Technical Service Bulletin							
Date Issued		Model Year(s) Affected		Model(s) Affected		TSB #	
10/20/2006		All ISC Engines prior to eng. ser. #46447925		Spartan Chassis Cummins ISL Engines		279	
Brand						Type	
All	<input checked="" type="checkbox"/>	American Star	<input type="checkbox"/>	Mountain Aire	<input type="checkbox"/>	All	<input type="checkbox"/>
		Dutch Star	<input type="checkbox"/>	Kountry Aire	<input type="checkbox"/>	F W	<input type="checkbox"/>
		Kountry Star	<input type="checkbox"/>	Essex	<input type="checkbox"/>	D P	<input checked="" type="checkbox"/>
Scottsdale	<input type="checkbox"/>	Northern Star	<input type="checkbox"/>	London Aire	<input type="checkbox"/>	D B	<input checked="" type="checkbox"/>
<div style="display: flex; justify-content: space-between;"> <div> <input type="checkbox"/> Air Conditioning & Heating <input type="checkbox"/> Appliances & Accessories <input type="checkbox"/> Cabinets & Furniture <input checked="" type="checkbox"/> Chassis Components <input type="checkbox"/> Construction Components </div> <div> <input type="checkbox"/> Electrical Components <input type="checkbox"/> Exterior Components <input type="checkbox"/> Interior Components <i

- **New Drawing:**

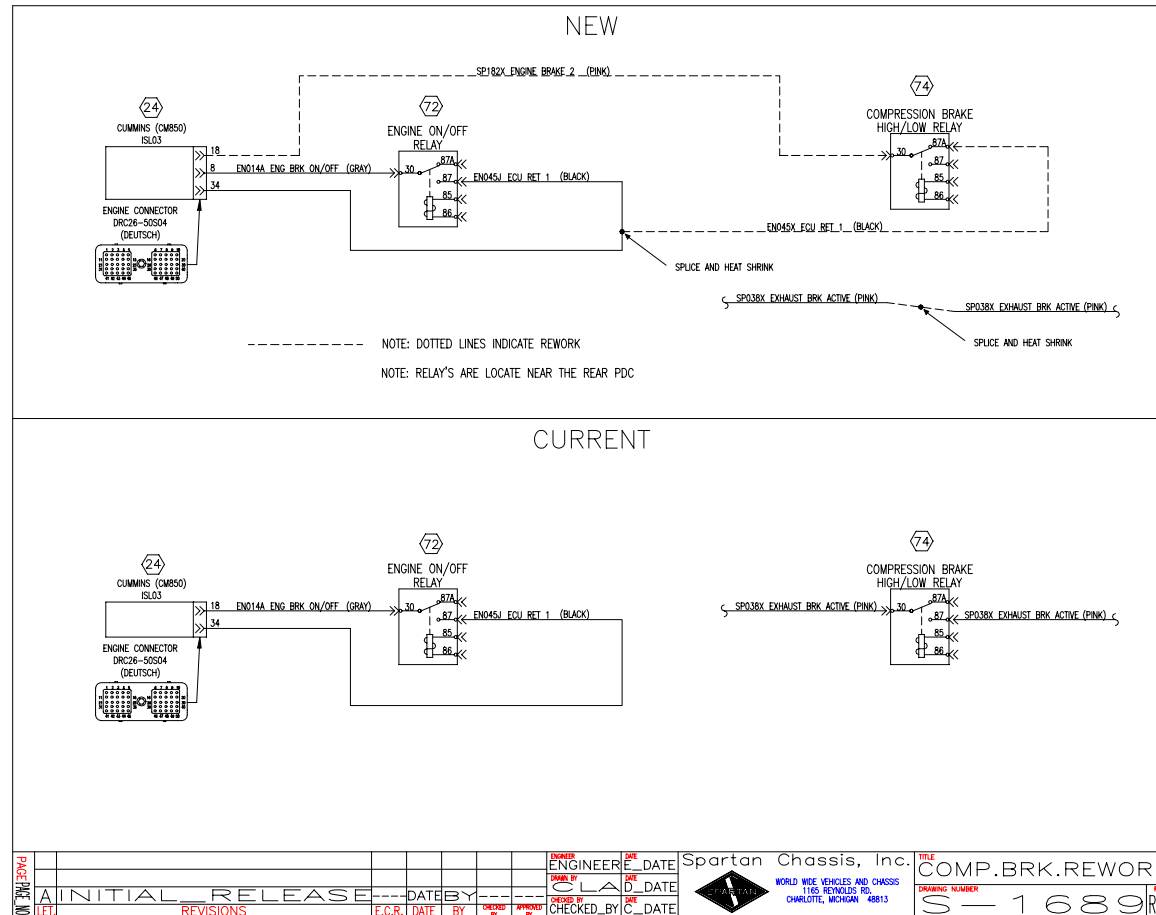
- Using the 2413-GG5 harness as a reference, locate the following:

Item 74 - Compression Brake Low/High Relay
Item 72 - Aux Brake On/Off
Item 24 - Engine ECM Connector

- 1) Remove SP038X and SP038Y from item 74 cavities 30 and 87 and splice together.
- 2) Move EN014A from item 24 cavity 18 to item 24 cavity 8.

- 3) Locate EN045J coming from item 72 cavity 87. Splice into EN045J and run the new wire to item 74 cavity 18. Use heat shrink to cover the splice.
- 4) Add a new wire (SP182X) from item 74 cavity 30 to item 24 cavity 18.
- 5) Reprogram the engine ECM with the revised software to allow the HI/LO compression brake to function. Verify the ESN before reprogramming.
